# SERVICE BULLETIN

Classification: EL94-010	Section: Electrical	Models: 1995 Maxima (A32)
Reference: TECHNICAL BULLETIN NTB94-064	Date: June 21, 1994

## 1995 MAXIMA (A32) REVISION TO FACTORY PRE-WIRING FOR ACCESSORY CD PLAYER

Figure 1

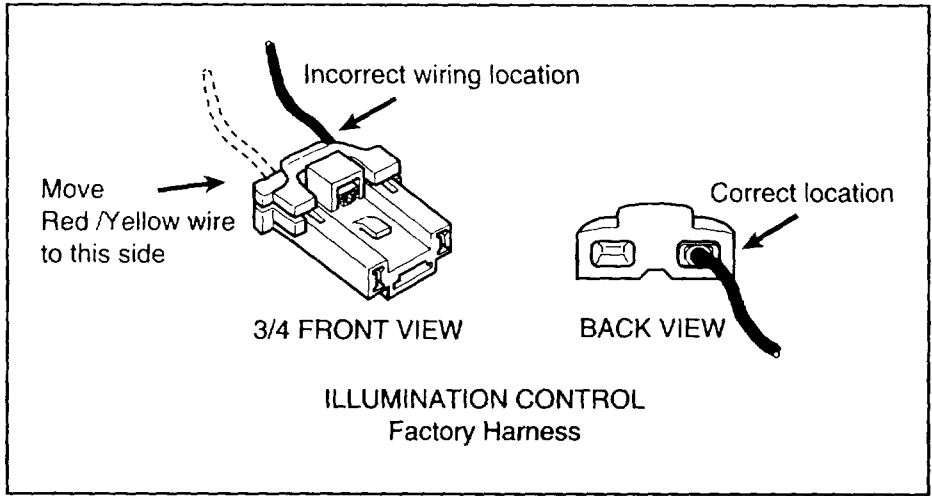
1995 Maxima (A32) vehicles, without the Bose audio system option, are pre-wired for an optional CD player. The illumination wire position in the body harness connector does not match the illumination connector on the Panasonic or the Sony CD players.

**Prior to installation of either the Sony or Panasonic CD, the red with yellow stripe (R/Y) wire and pin must be moved to the other hole in the connector for proper CD illumination.**

8. Using a flat blade (3 mm-wide) screwdriver, open the plastic cover on the back of the black-colored connector [2-pin; 1-wire (R/Y=red with yellow stripe)]. (Figure 1) Push out the R/Y wire and pin; then, reinstall the wire and pin on the other side of the connector. Close the plastic cover.
